# Planning Scheme Amendment C339ggee Flood overlays and zones

## REVIEW OF COMPLEX SUBMISSIONS – LARA, AVALON AND FYANSFORD

City of Greater Geelong

July 2022

**Figure 16 Comparison of flooding at Lara**

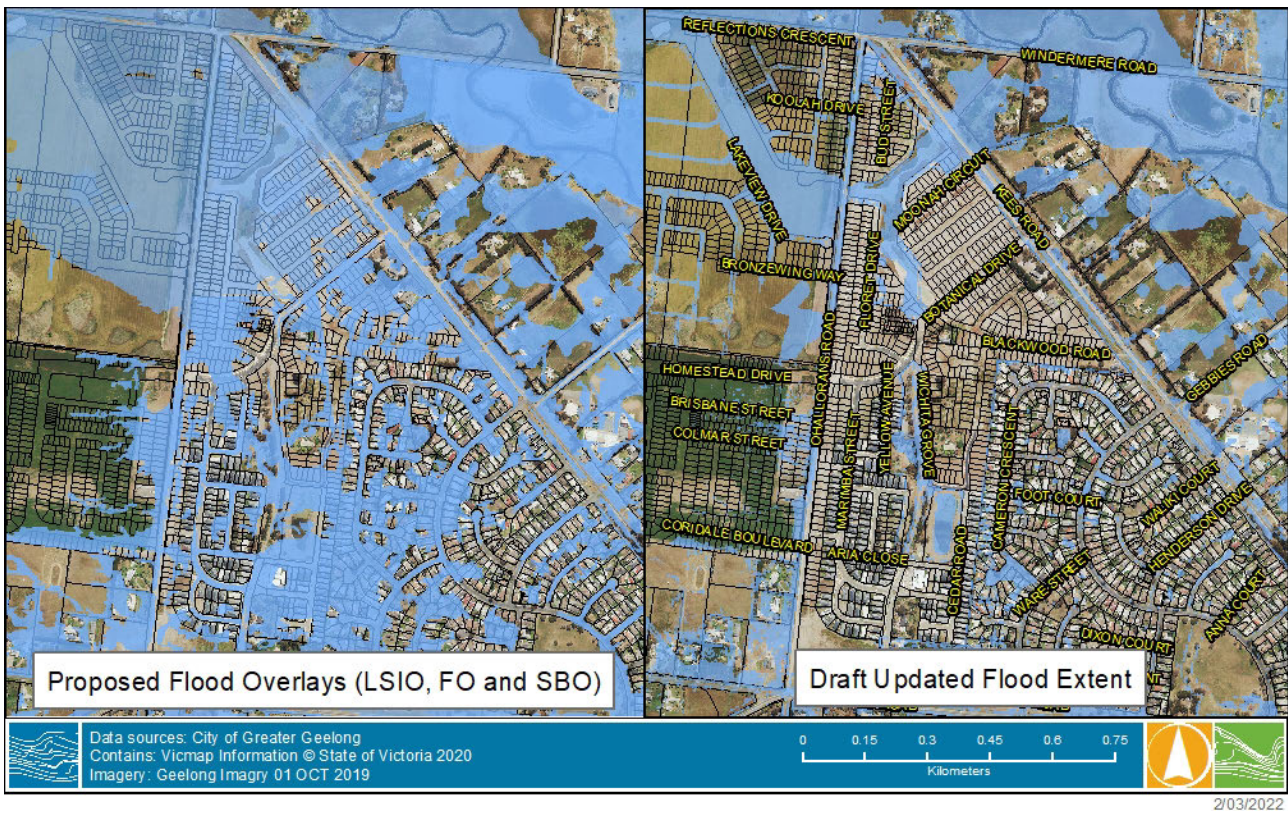
A comparison of the exhibited SBO extent and the draft updated flood extent is shown in Figure 16 below.

**Figure 17 Area to be omitted (within red outline)**

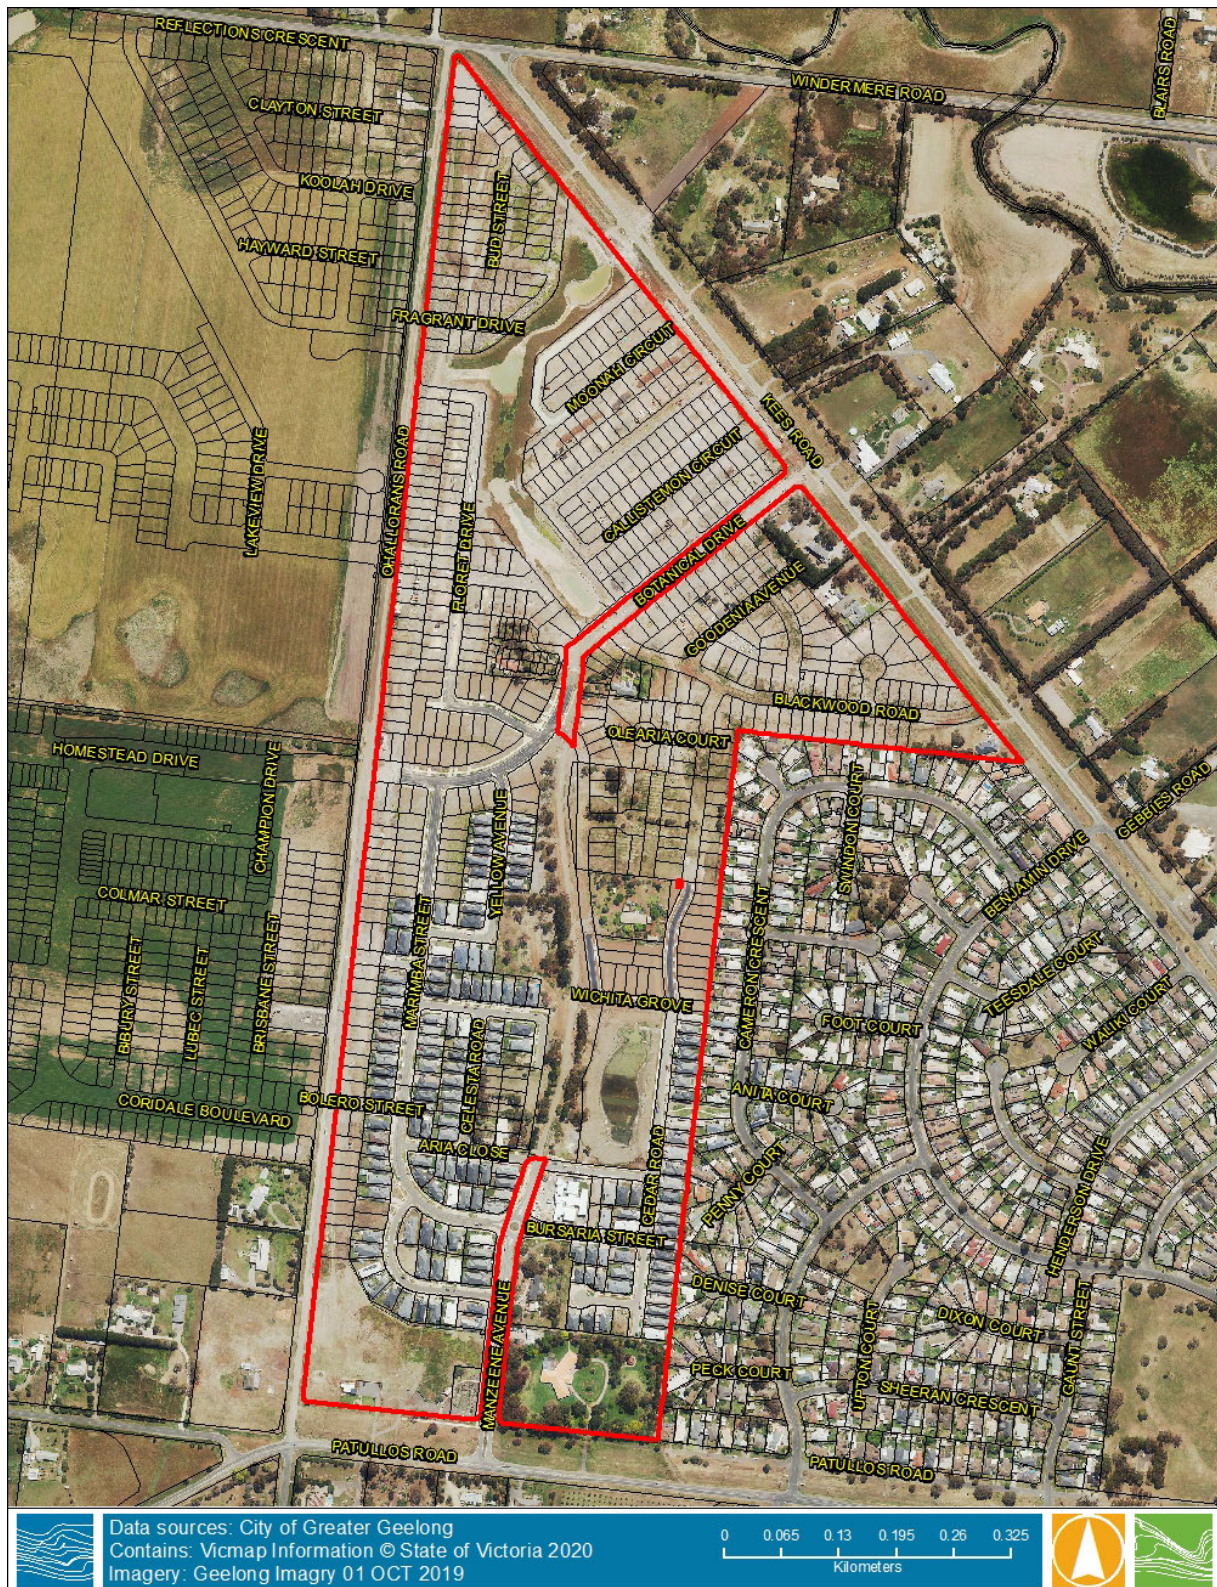
As part of the Hovells Creek Stormwater Management Plan and Growth Area Surface Water Planning the overland flooding and drainage conditions within this section of the catchment will be updated. With rapidly evolving development works to the west and the completion of outstanding earthworks within the development it is recommended that, at this time, the Manzeene Village development area be omitted from the planning scheme amendment. It is understood that development at this location was based on detailed flooding assessment on which mitigation measure were proposed and subsequently constructed which protects buildings from the potential impact of inundation during the 1% AEP design flood. In light of this, it is considered that omitting this area until such time as updated, appropriate flood mapping is available presents a manageable risk and would provide a better planning outcome (as shown in Figure 17).

**Figure 19** Area to be removed from amendment

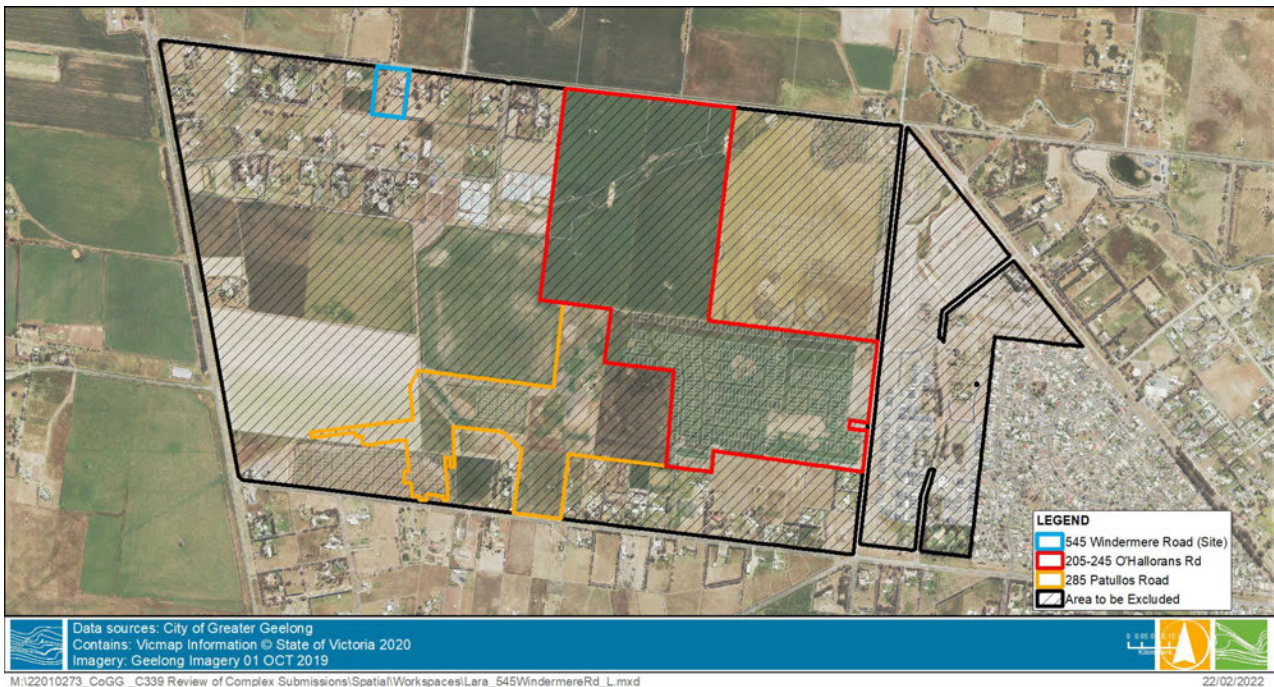
Whilst the property at 545 Windermere Road shown in Figure 18 is recommended to be removed for this amendment it is also recommended that the flood prone designation remain in place. Unlike the other two properties identified in this area, 545 Windermere Road is not part of the larger land holdings where works are ongoing to develop the Lara West area. Hence there is no immediate plan to resolve flooding risk here, with no current application to develop the site. This means there is residual flood risk across the site until such time as development within this area of Lara West proceeds and residual flood risks are addressed.

**Figure 22** Area to be omitted

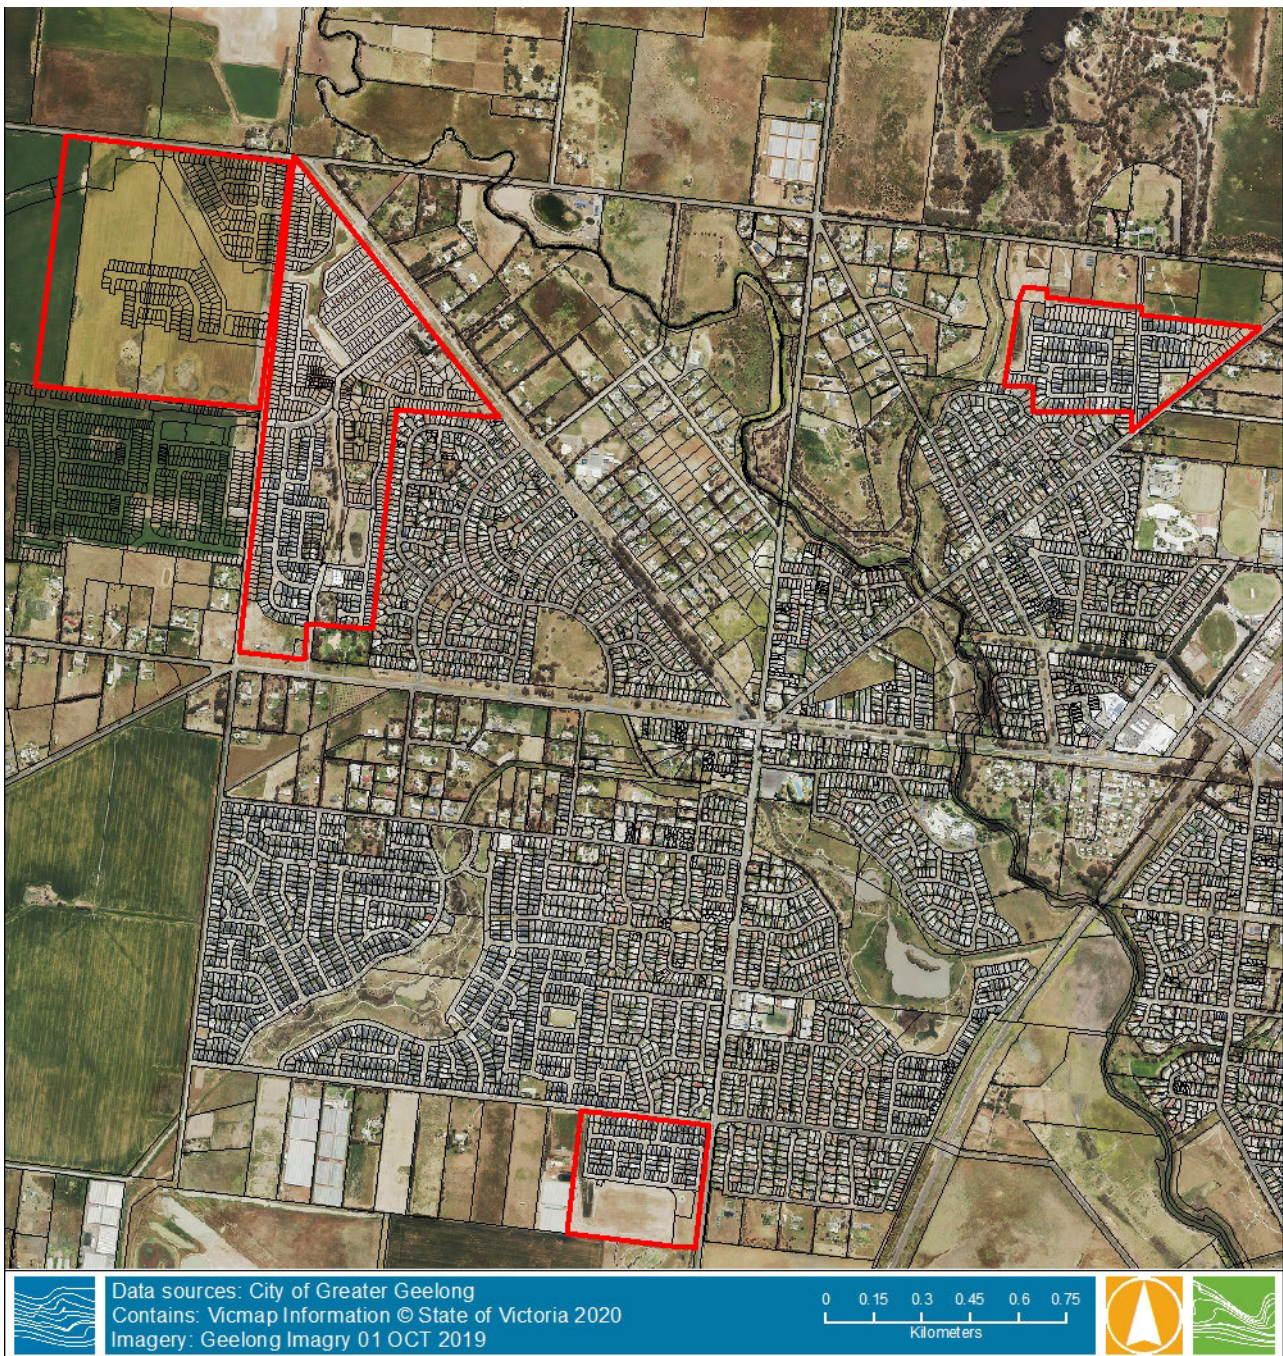
The areas to be omitted from the current amendment are shown in Figure 22 below.

Figure 29 1% AEP Flood extent comparison

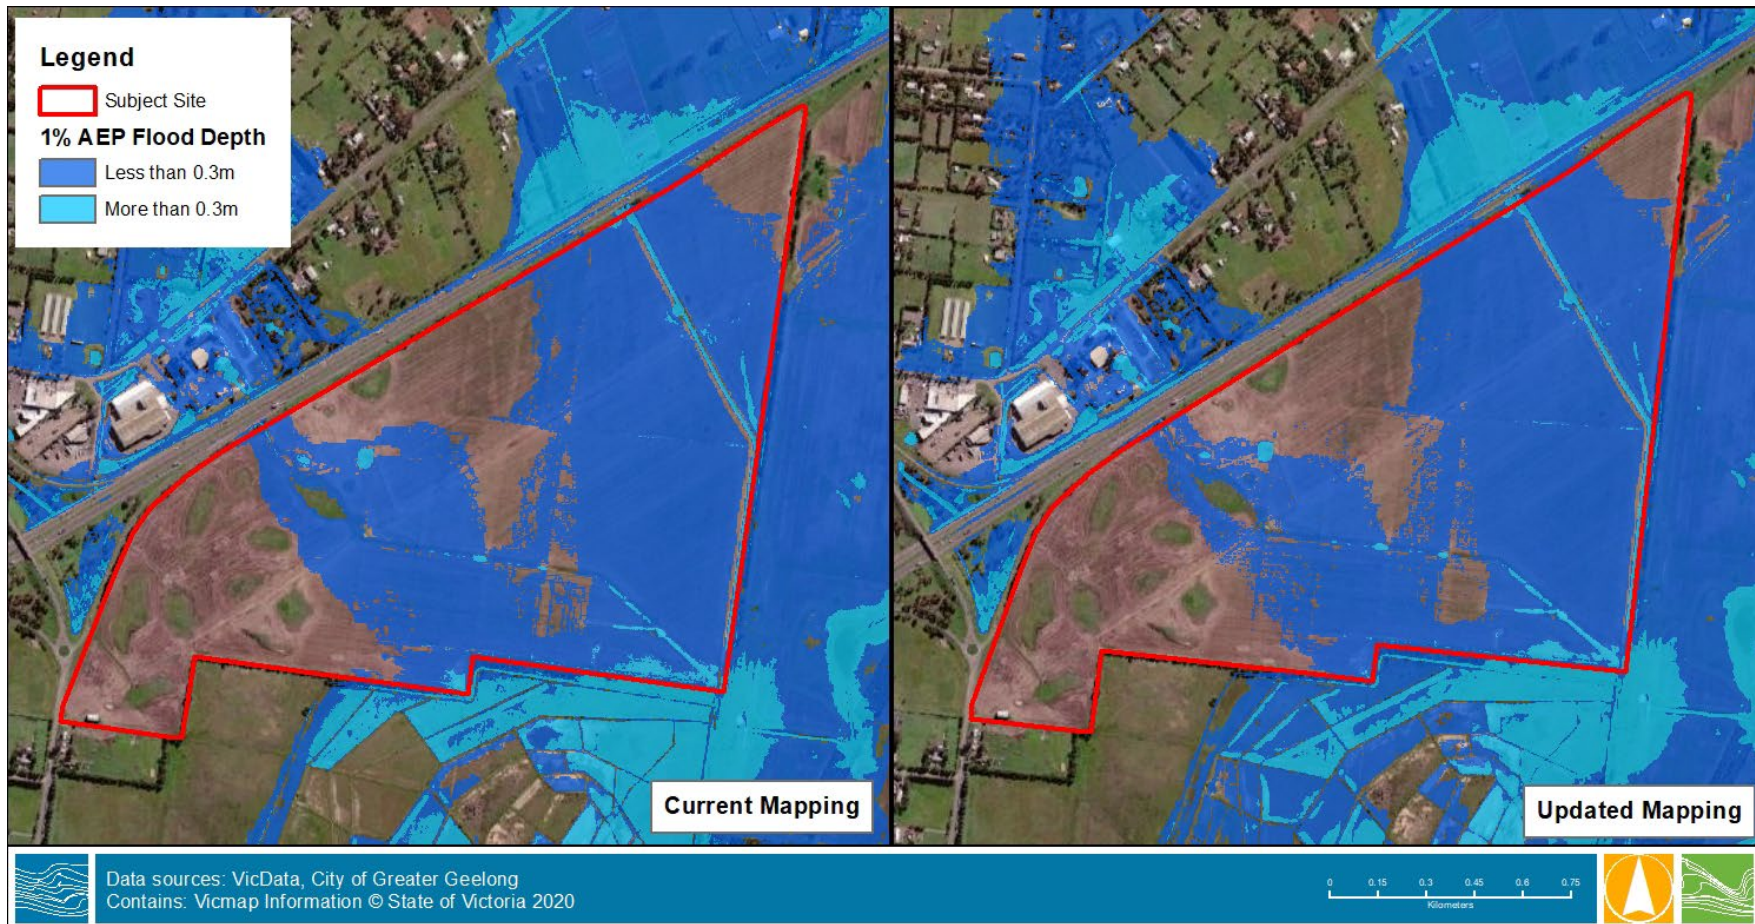
The maximum flood depth results of the updated model have been compared to the previous results from the Lara Flood Study. The assessment indicated a minor change in flooding extent at the location of the northern crossing. Under both scenarios the Princes Highway is overtopped in the 1% AEP flood event. Whilst the capacity of the culverts has changed this has resulted in an increase in flood levels upstream of the highway leading to an increase in water overtopping the road as shown in Figure 6-28. Flood Levels upstream and downstream of the highway adjacent to the northern culverts are shown in the Table below:

Having regard to the above it is recommended that the **flood overlays at this location are applied as exhibited**. The flooding extent at the location of the northern culverts has been shown to be consistent with previous modelling furthermore modelling results of the southern culvert whilst slightly request still shown an extent similar to that exhibited (LSIO) with remaining questions regarding the likely existence of a single or double string which is shown to reduce the flow across the highway at this location.

**Figure 32 1% AEP Flood extent comparison and boundary locations**

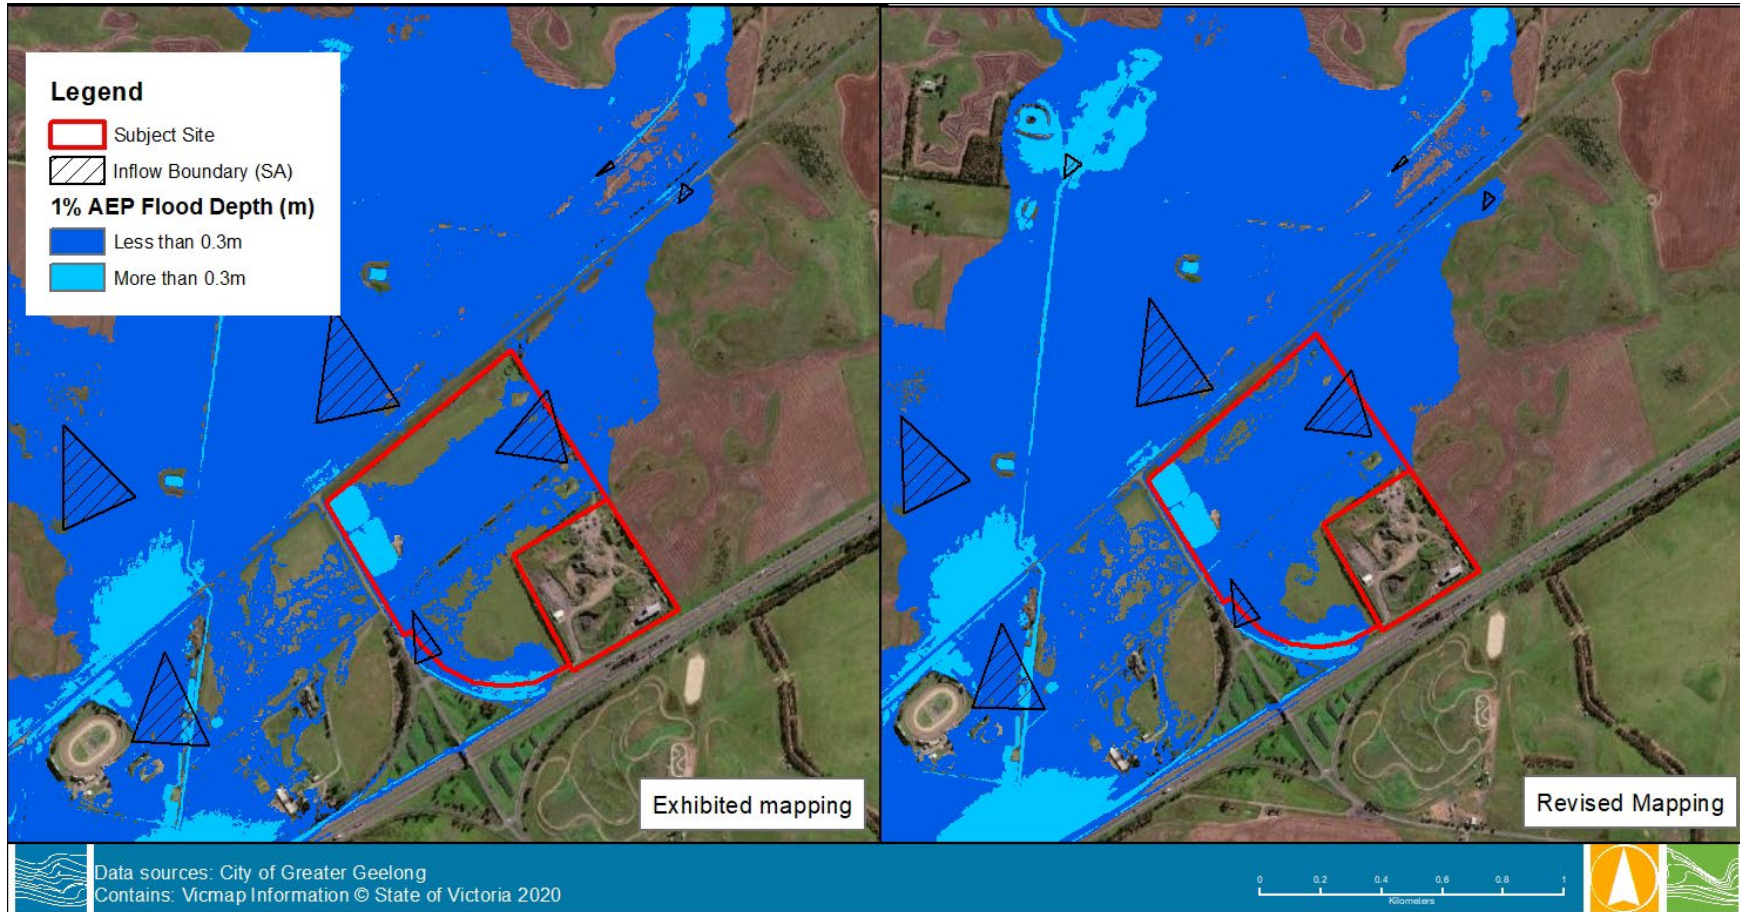
The results of the revised flood mapping are shown in Figure 31. The flood depth results indicate an increase in the flooding extent onsite associated with the changes to the model. The flooding extent has increased within the northern portion of the site adjacent to Old Melbourne Road. Flooding depths within this area of increased extent are between 1-3 cm. This is predominantly associated with the inflow now being located on the downstream side of the Old Melbourne Road culverts which is inputting more water into the model immediately upstream of the site.

Based on the results of the revised mapping indicating an increase in flooding extent with very shallow depths it is recommended that the **flood overlays at this location are applied as exhibited**.
